West Island Line Project

## **Method Statement for capping slab removal for 714 site office area**

Document No.: 3295-MS-0251

## Appendix E – Response to Comments received from EPD

**Figure 2.1 Different zonings for removal works of Works Area B**

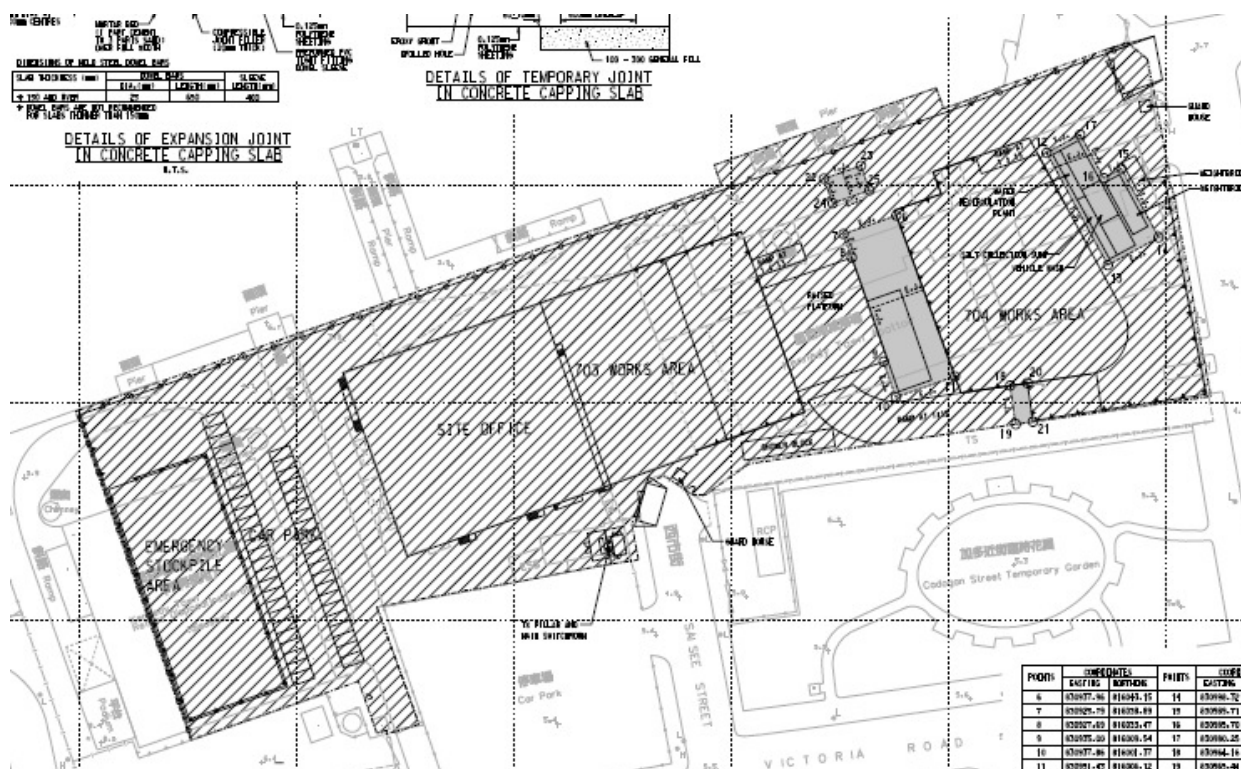
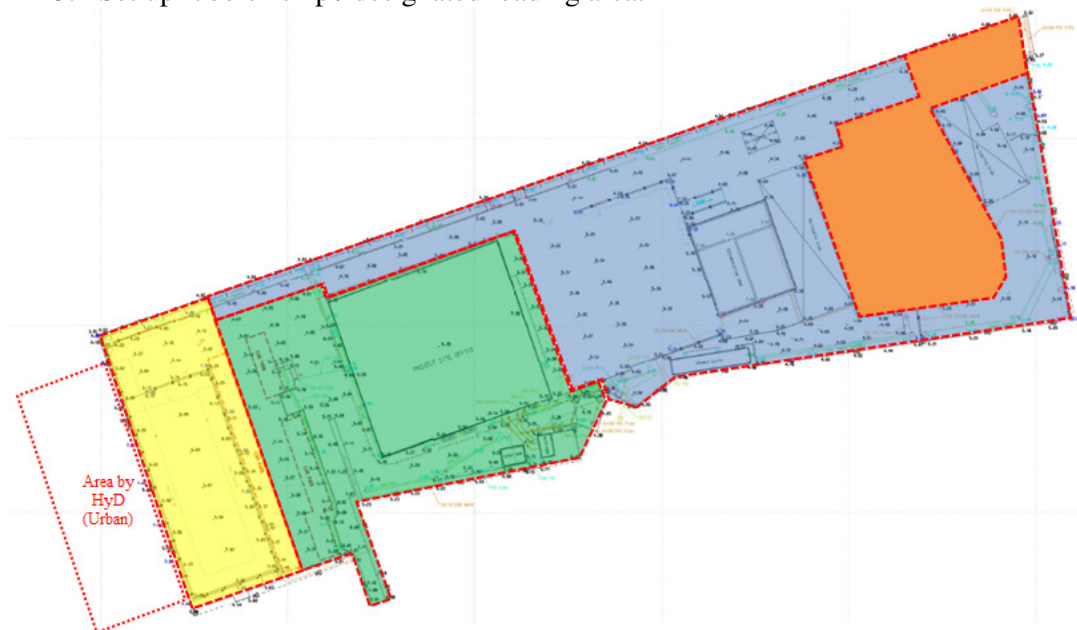
Comments received from EPD dated 17 April 2015	Response to Comments
<p>General</p> <p>The project proponent is reminded to follow strictly to the EM&amp;A Manual when carrying out the works.</p>	<p>Noted.</p>
<p>General</p> <p>Figures in Section 1.2 and Section 2.2: - Please improve on the readability of the figures and reference shall be added under each figure.</p>	<p>Noted and reference has been added under each figure.</p>
<p>Air Quality</p> <p>Section 2.3: Step 12. It is advised that completed area shall be conducted by responsible persons, eg. Surveyor / ET such that any cracks or contamination leakage can be detected at an</p>	<p>Noted and text in Step 12 has been revised.</p>

SCALE 1:500 @A1  
DRAWING NO. 714/Z/300/SFK/C24/201

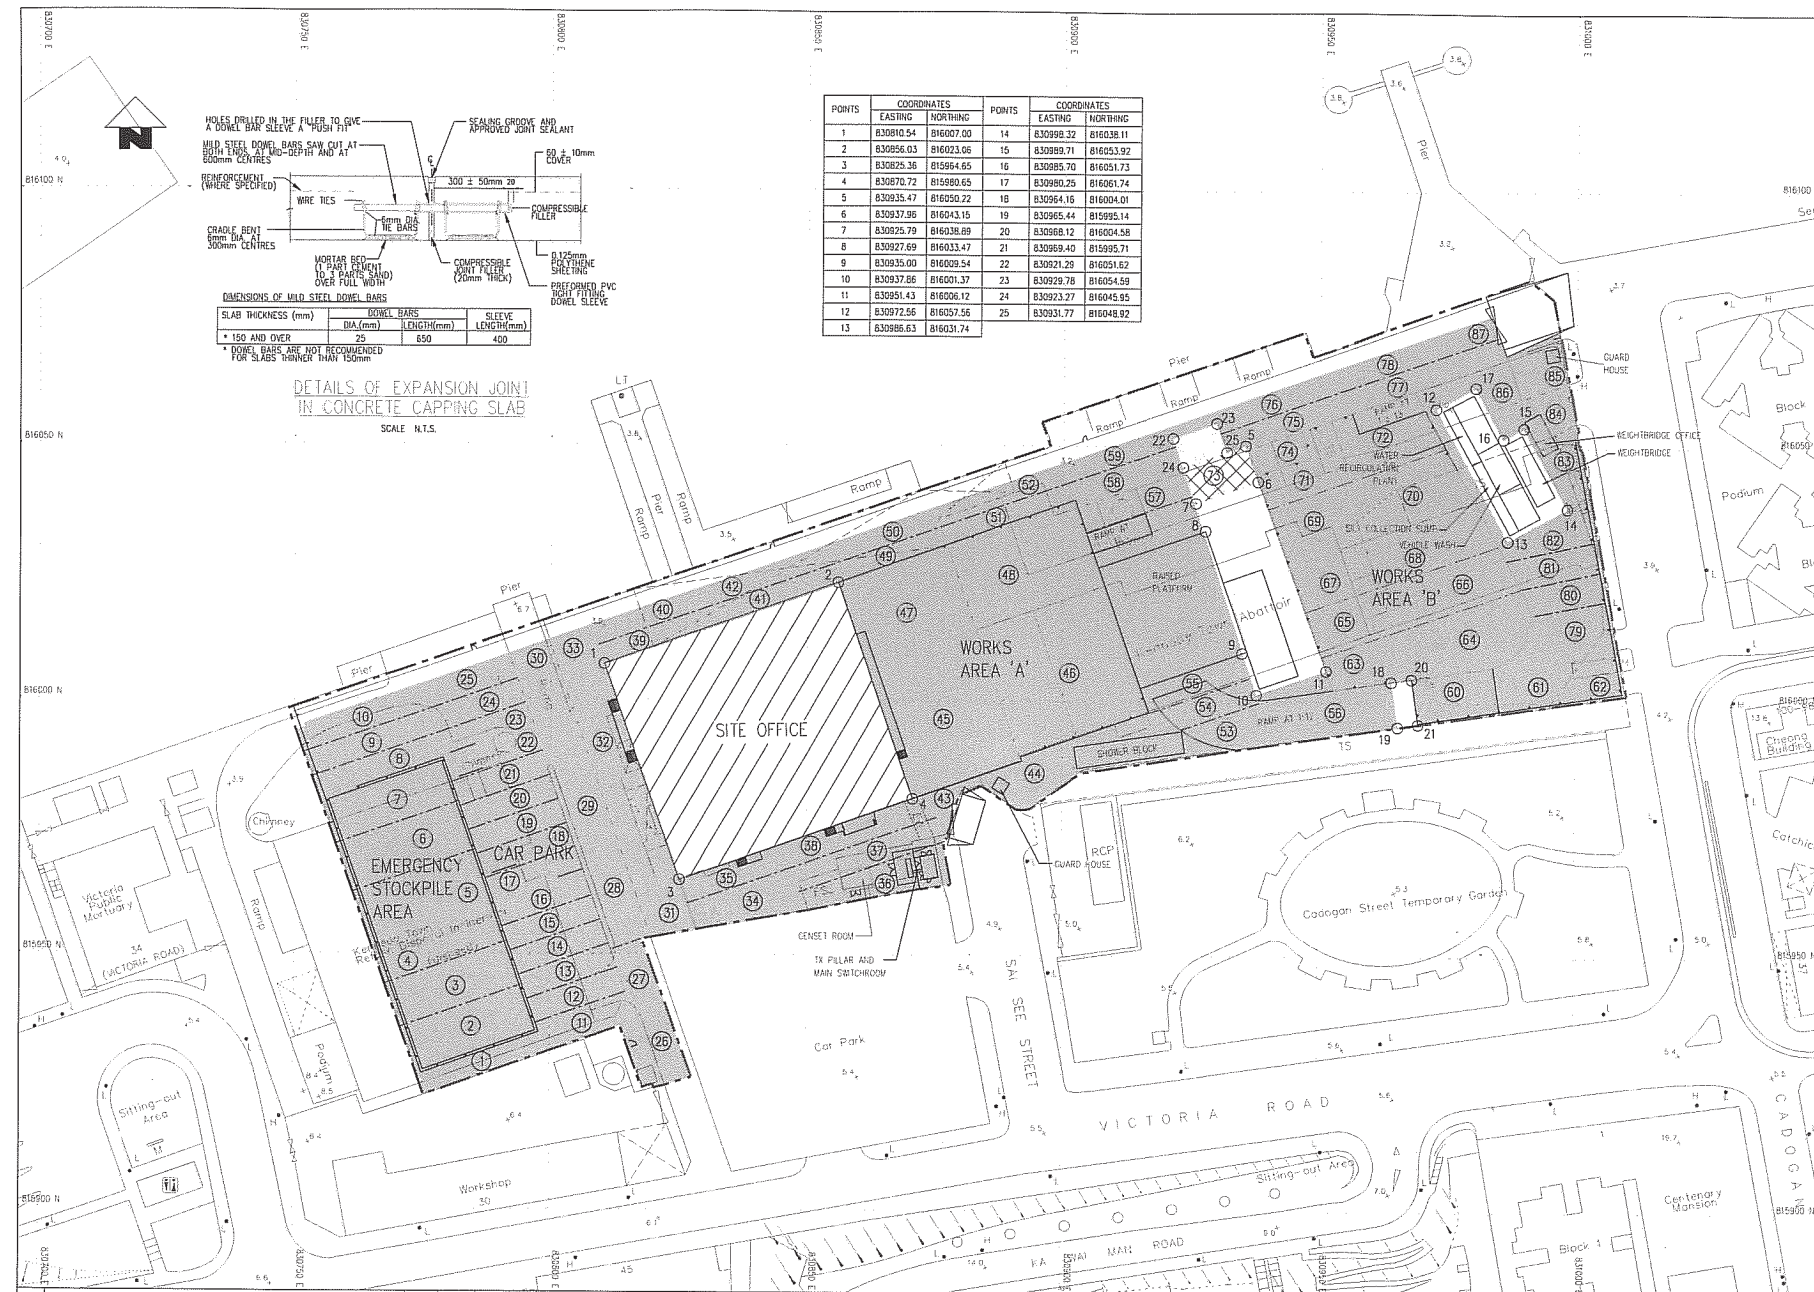
Comments received from EPD dated 30 April 2015	Response to Comments
<p><b><u>Waste</u></b></p> <p>(i) Steps 6 and 9 of Section 2.3 and Appendix A</p> <ul style="list-style-type: none"> <li>As the thickness of additional concrete paving at some areas (e.g. Site Office) is only 200mm, the project proponent need to propose necessary measure(s) to avoid the mis-use of hammer head longer than 200mm (i.e. 225mm) at such areas. Please revise texts as appropriate.</li> <li>Re. Appendix A, please clarify what is the thickness of additional concrete paving for some areas which are shown as "white". Please also state the thickness of additional concrete paving for these areas as appropriate.</li> </ul> <p>(ii) It is clarified in RtC item (ix) that "remedial works will still be carried out if the width is equal to or smaller than 0.5cm". To avoid any confusion, please clearly state in Step 12 of Section 2.3 accordingly.</p> <p>(iii) Section 3.1 - To avoid any confusion, please use the terms "Inert C&amp;D Materials" and "Non-inert C&amp;D Materials" to replace "Inert Waste - C&amp;D Materials" and "Non-inert Waste" respectively in the whole section.</p> <p>(iv) 2nd Para., Section 3.1 - Should last senetence read as "All waste concrete and soil will be disposed/<u>reused</u> as normal inert <u>C&amp;D</u> material, either at Tuen Mun Area 38 Fill Bank or alternative disposal site/<u>other construction site(s)</u>, if any, to be approved by MTR." ?</p>	<p>Noted. Step 9 of Section 2.3 was revised to include demarcation of area for additional concrete paving with depth of 200mm</p> <p>The thickness of additional concrete paving for the white area is at least 225mm.</p> <p>Text was revised in Step 12 of Section 2.3.</p> <p>Noted and relevant text was revised in Section 3.1.</p> <p>Relevant sentence was revised.</p>

early stage.	
<p>Waste General</p> <p>(i) The terms "additional concrete paving", "existing concrete paving" and "general fill material" are used in the Clauses 3.3.2 &amp; 3.3.3 of the Environmental Permit No. EP-313/2008/J. To avoid any confusion, please avoid using other different terms (e.g. capping slab, original capping slab, temporary paving layer, soil, general fills, etc.) and use a consistent term in the Method Statement. Please revise relevant texts as appropriate.</p> <p>Specific</p> <p>(ii) Figure in Section 1.2 - The areas highlighted with "green" / "yellow" colour in this Figure do not tally with the "site boundary" as shown in Appendix A. To avoid any confusion, please revise the Figure as appropriate.</p> <p>(iii) 1st para., Section 1.2 - According to Clause 3.3.2(c) of the Environmental Permit No. EP-313/2008/J, the Method Statement shall include the removal, temporary storage and treatment if necessary, and disposal of the additional concrete paving and general fill material. Please revise as appropriate.</p> <p>(iv) 3rd para., Section 1.2 - To avoid any confusion, please clarify whether the 1st sentence should read as "It has been proven that the general fill material between the additional concrete paving and existing concrete paving is NOT contaminated".</p> <p>(v) Section 2.2 and Appendix B - The "blue and orange area" will be vacated first for the removal works according to Step 1 of Section 2.2, while the steps will be repeated for "yellow and green area" once available (i.e. Step 13 of Section 2.3 refers). However, it seems that such works programme for various areas does not tally with the programme as shown in Appendix B. Please clarify and revise as appropriate.</p> <p>(vi) Steps 6 and 9, Section 2.3</p> <p>* Referring to Figure 15 of the Environmental Permit No. EP-313/2008/J, the thickness of "additional concrete paving" is "225 mm". Please clarify whether the thickness of the additional concrete paving is "225 mm" or "350mm" for the whole site. Please revise the length of hammer head and</p>	<p>Relevant text has been revised to avoid confusion.</p> <p>The figure is replaced by extract from Appendix A.</p> <p>Noted and the text in Section 1.2 has been revised.</p> <p>Noted and the text in Section 1.2 has been revised.</p> <p>Updated programme is attached in Appendix B and the relevant text in Section 2.2 has been revised.</p> <p>The additional concrete paving is either 200mm or 225mm. Please refer to the as-built drawing of capping slab 714/Z/300/SFK/C24/201 Rev 0 for the area in Appendix A. The length of hammer</p>

<p>relevant texts as appropriate if the thickness is "225 mm". However, in case the thickness is "350 mm", please provide documentary evidence for confirmation.</p> <p>* Please further elaborate whether there will be any measures to avoid the damage of the existing concrete paving by the excavator/hammer, in particular for those areas that there is only a layer of "de-bonding material" in between the additional concrete paving and existing concrete paving (i.e. Section 3.1.7 of "Justification of Alternative Capping Slab Design for Works Area B" submitted for application of VEP in 2010 refers).</p> <p>(vii) 2nd para., Section 3.1</p> <p>* Please clarify whether the "filling material" should be the "general fill material" between the additional concrete paving to be removed and the existing concrete paving. If affirmative, please revise as appropriate.</p> <p>* Please clarify whether "original capping slab" should read as "existing concrete paving" which is the term used in the Environmental Permit No. EP-313/2008/J.</p> <p>* Please further elaborate what is the "alternative disposal site as approved by MTR" ?</p> <p>* As there is a layer of "de-bonding material" in between the additional concrete paving and existing concrete paving, please clarify whether the "de-bonding material" is non-inert C&amp;D material or not. Please also address the proper handling and disposal of the "de-bonding material" as appropriate.</p> <p>(viii) Appendix C - As the site will subsequently be handed over to the CEDD via LandsD, please seek written advice from the CEDD / LandsD on whether the proposed remedial material (i.e. Renderoc FC) for the cracks of "existing concrete paving" is acceptable.</p>	<p>head will follow the thickness of the additional concrete paving according to this plan. Text in Steps 6 and 9 of section 2.3 have been revised.</p> <p>Text revised for further elaboration.</p> <p>Noted and the text has been revised.</p> <p>Noted and the text has been revised.</p> <p>As the general fill material is confirmed not contaminated, in order to enhance the material reuse and release the burden of Fill Bank, alternative disposal sites such as reclamation projects, projects with backfilling works, etc. will be sought for disposal, subject to approval.</p> <p>A polythene sheet was used as the de-bonding material between two concrete pavings. Handling and disposal of this material has been included in Section 3.1.</p> <p>Alternative material, Nitofill EPLV, was proposed and approved by CEDD. Relevant approval is attached in this Appendix.</p>

Note:  
The thickness of the additional concrete paving in the white area is at least 225mm.

## 714 DEMOLITION PROGRAMME

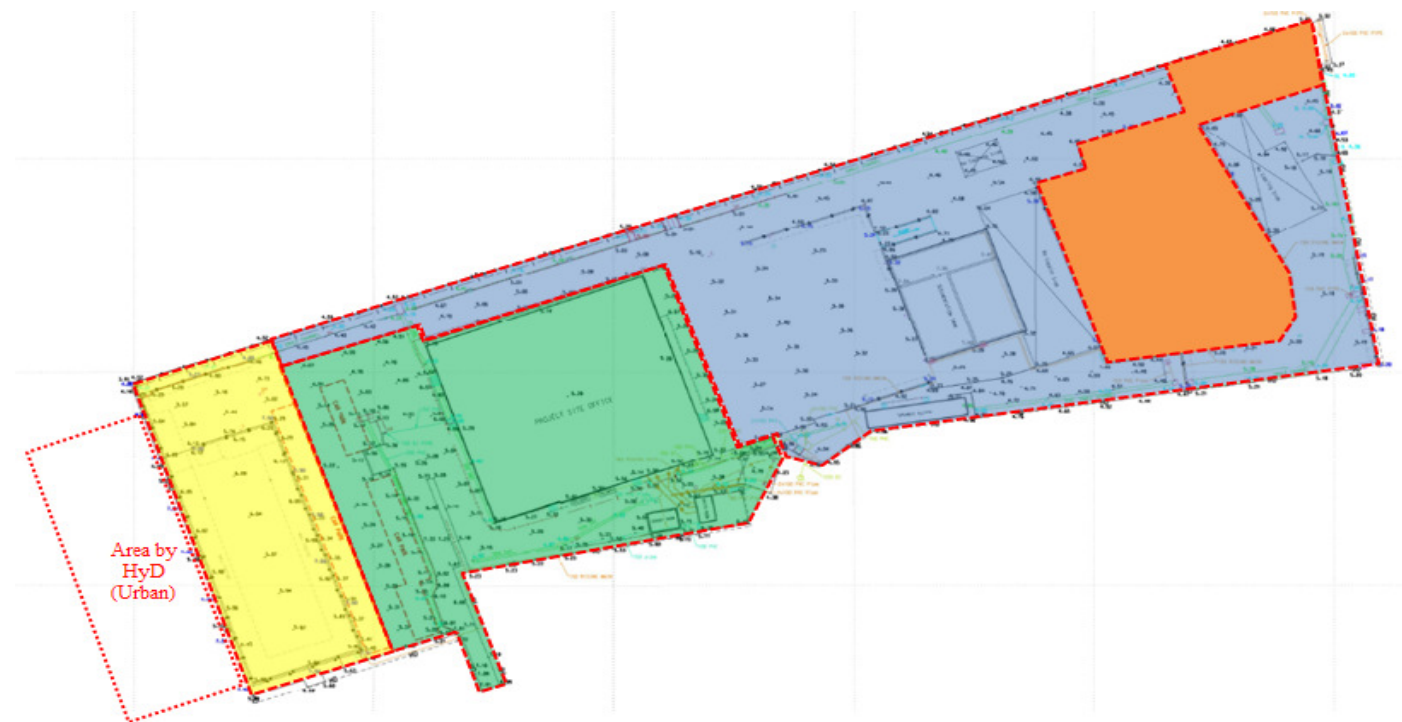
Comments received from EPD dated 8 May 2015	Response to Comments
<p>We have no further comment on the revised method statement and RtC except for the minor comment below:</p> <p><u>RtC - 3rd bullet of item (vi)</u></p> <ul style="list-style-type: none"> <li>The general fill materials (if any) in the area underneath the project site office should also be removed. However, if the project proponent/ consultants confirm that there is no general fill materials in the area underneath the project site office, please state accordingly to avoid any confusion.</li> </ul>	<p>It is confirmed that there is no general fill materials in the area underneath the project site office, a remark was added in the program.</p>

<p>(v) 3rd Para., Section 3.1</p> <ul style="list-style-type: none"> <li>Please state the disposal outlet for the "Non-inert C&amp;D material".</li> <li>Please note that "Non-inert C&amp;D material" and "general refuse" are two different types of wastes and their handling/disposal are different. Please delete/revise texts as appropriate.</li> </ul>	<p>Noted and SENT Landfill will be the disposal outlet for the non-inert C&amp;D materials.</p> <p>Noted and relevant text was revised in Section 3.1.</p>
<p>(vi) Appendix B</p> <ul style="list-style-type: none"> <li>Please clarify whether the notes for "Removal Plan", "STR", "RAP" and "Potential Contaminants" under the table are to be removed.</li> <li>Please ensure the sequence of works in this programme be consistent with that stated in Step 1 of Section 2.2. Please revise as appropriate.</li> <li>Item 3h - Please clarify whether there is any removal of "general fill materials" for Green Area. Please revise as appropriate.</li> <li>The item "Making Good of Existing Concrete Paving" is missing under the "Green Area (Project Office)". Please clarify.</li> </ul>	<p>Relevant notes were deleted.</p> <p>Noted and the text in Step 1 of Section 2.2 was revised to suit.</p> <p>Removal of general fill materials will also be carried out in the Green Area, except the area underneath the project site office. Relevant text in the programme was revised.</p> <p>Noted and the programme was revised in Appendix B.</p>

Note:  
 BLUE = WORKS  
 GREEN = DEMOBILIZATION  
 # There is no general fill materials in the area underneath the Project Site Office.
